66319B-05

S E R V I C E N O T E

66319B

Reliability Improvement of Instrument

CORRECT J207 PLACEMENT – alignment to within $< 0.3\text{mm}$

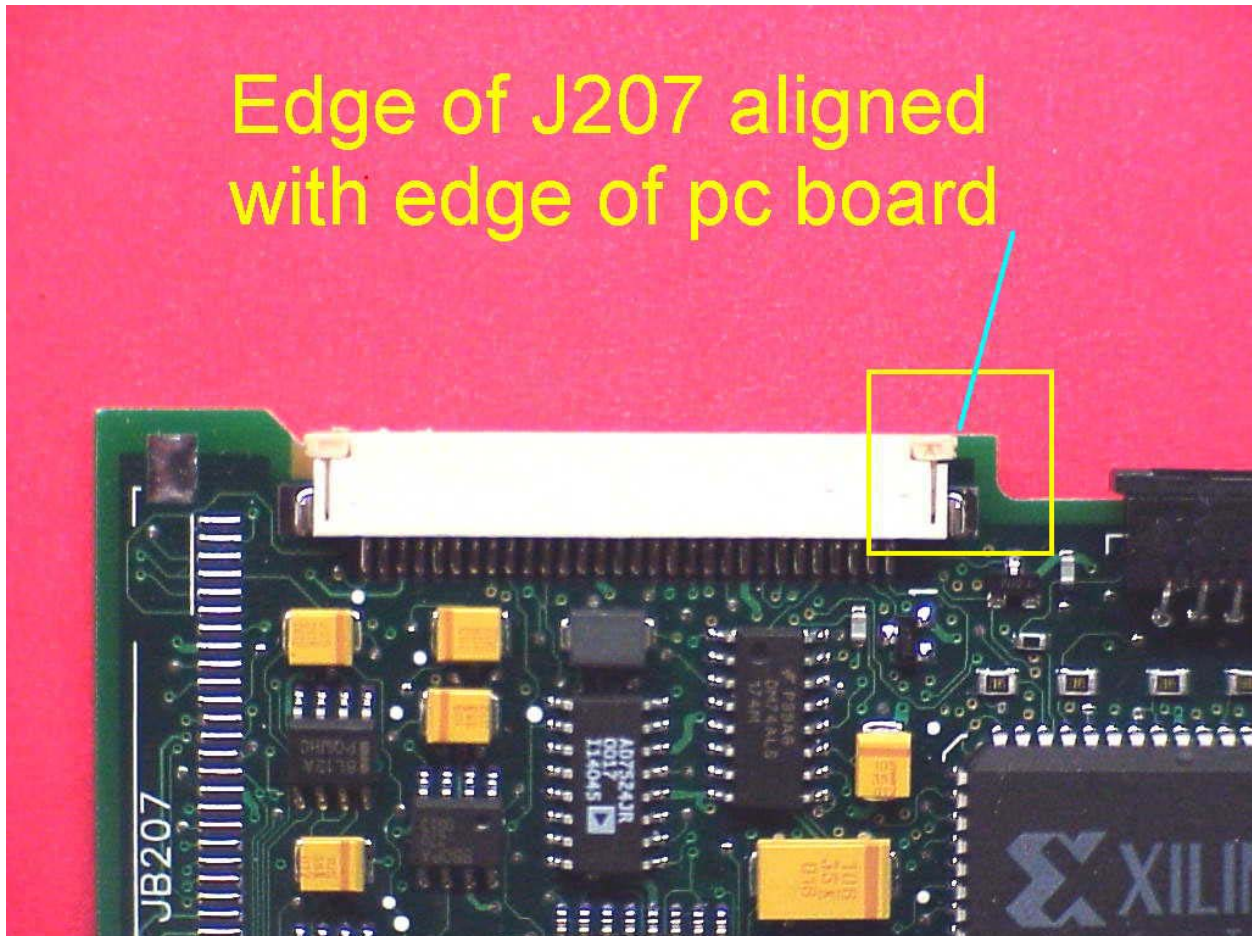
Latent product failure due to misplaced connector J207 on SMT assembly 5064-0018 (GPIB/RS232 interface). Misplacement of J207 could lead to inadvertent contact/shorting of exposed feed-throughs on SMT board. Ultimately, resulting in over-stress of components of damage to SMT board components. Resulting contact could degrade useful life of instrument.

Picture shows connector aligned to edge of SMT board to within $< 0.1\text{mm}$

- 1) Compare placement of J207 to attached photos. Instruments with a “misplaced” J207 should be returned to Agilent for warranty repair.
- 2) Instruments returned to the Service Center for routine calibration should be inspected for this potential defect. Defects should be addressed using Agilent’s unit exchange process with costs being charged to warranty.
- 3) The factory has modified production documentation to include visual inspection and specific electrical testing for this potential short.
- 4) Factory is maintaining feedback to SMT board supplier regarding quality of assembly.

INCORRECT J207 PLACEMENT – misaligned by $> 0.3\text{mm}$

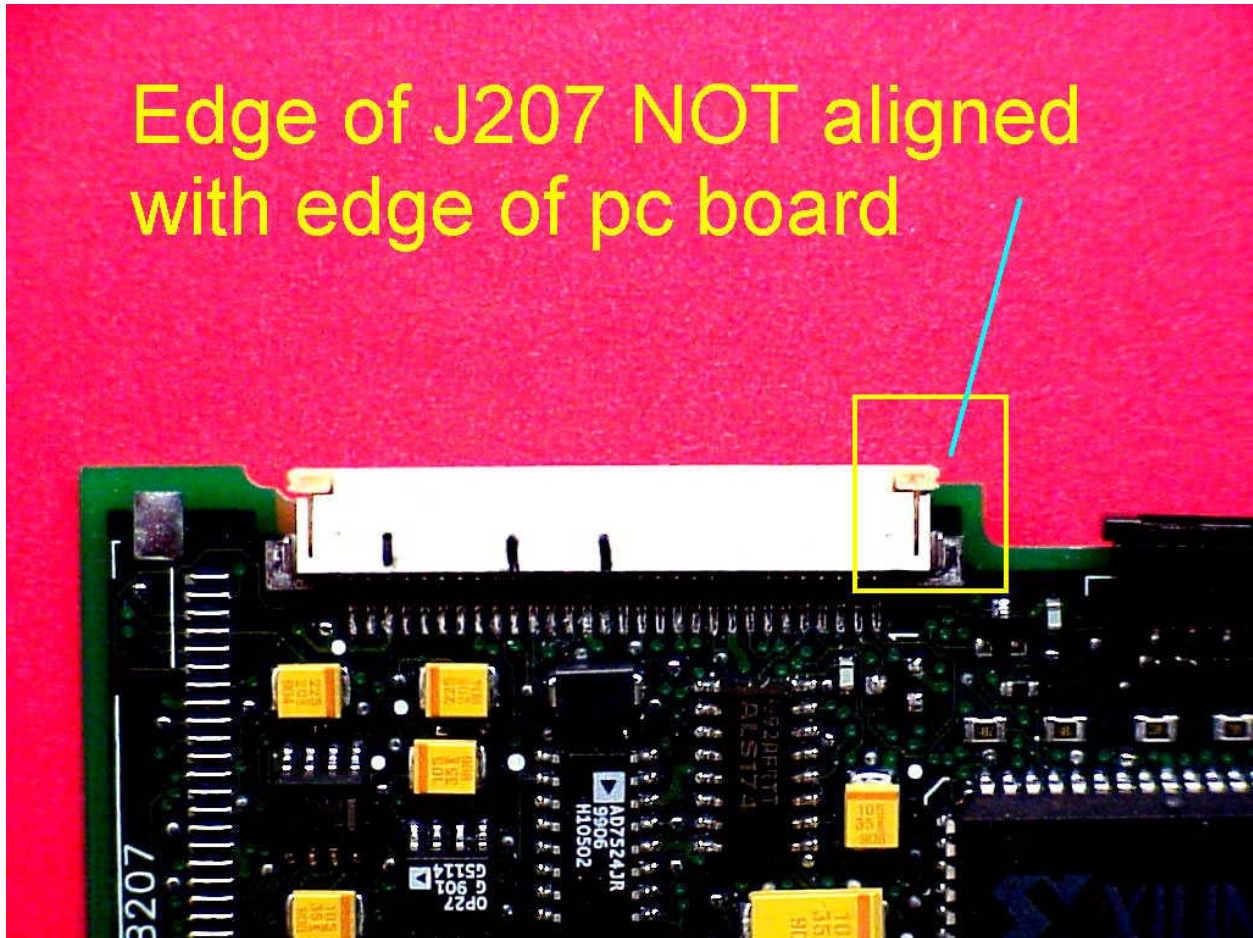
Picture shows connector extending past edge of SMT board by $>1.2\text{mm}$
